# UNITED STATES PATENT AND TRADEMARK OFFICE

APPLICATION NO.	FILING DATE	FIRST NAMED INVENTOR	ATTORNEY DOCKET NO.	CONFIRMATION NO.
10/721,223	11/26/2003	Jean-Francois Savaria	86267-39	5690

# Office Action Summary

## **DETAILED ACTION**

F I G. 2

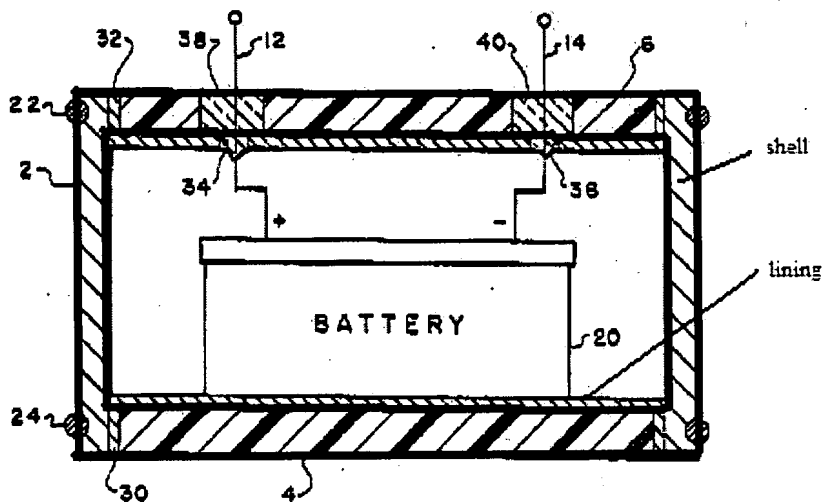
Regarding the Kelly reference, Applicants state that the shallow cup (32) cannot be considered to be both the liner and the reinforcement of the shell. In response, it is maintained that the portion of the cup that lies within the three-dimensional space of the shell can be characterized as a reinforcement of the shell. The Examiner's interpretation of the claimed "lining" and "shell" is shown in the following annotated drawing from Kelley:

As can be seen in the drawing, the end portions of the “cups” 30, 32 are located within the “shell,” the cross-section of which is denoted by the thick black line. As such, the different portions of the disclosed cups are believed to meet the claim limitations requiring a “lining” and a “reinforced” plastic.
